Our ref: DOC22/1002286

Your ref: SSI-10035

Subject: EHG comments on Environment Impact Statement for Parramatta Light Rail – Stage 2-SSI-10035

Subject: EHG comments on the Environment Impact Assessment for Parramatta Light Rail Stage 2 - SSI-10035

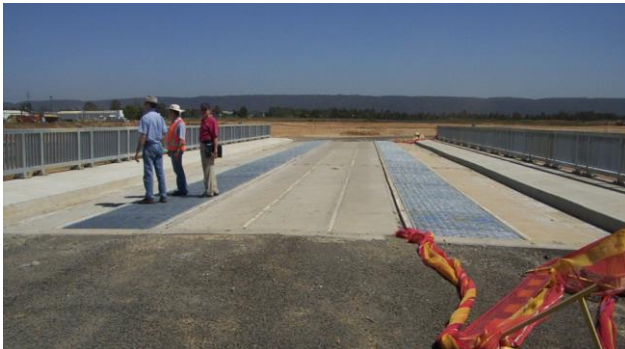
Whether or not the riparian corridor is currently vegetated with native vegetation, the EIS should assess the potential impact of the proposed bridge crossings on riparian land and the potential to rehabilitate and improve riparian connectivity. Mitigation measures need to be included to address this. Where riparian land is permanently impacted by the project it should be offset and details provided on this (see comments below).

EHG recommends that when the construction compounds at the Camellia -Rydalmere crossing (compound 2 and compound 3, see figure 7.8 – map 1) and Archer Park / Melrose Park/ Koonadan Reserve - Wentworth Point bridge (compound 8 and compound 9, see Figure 7.9 – map 2) are removed, any impacted riparian land (i.e., within 40m of the Parramatta River (measured from top of highest bank)) are replanted with local native species.
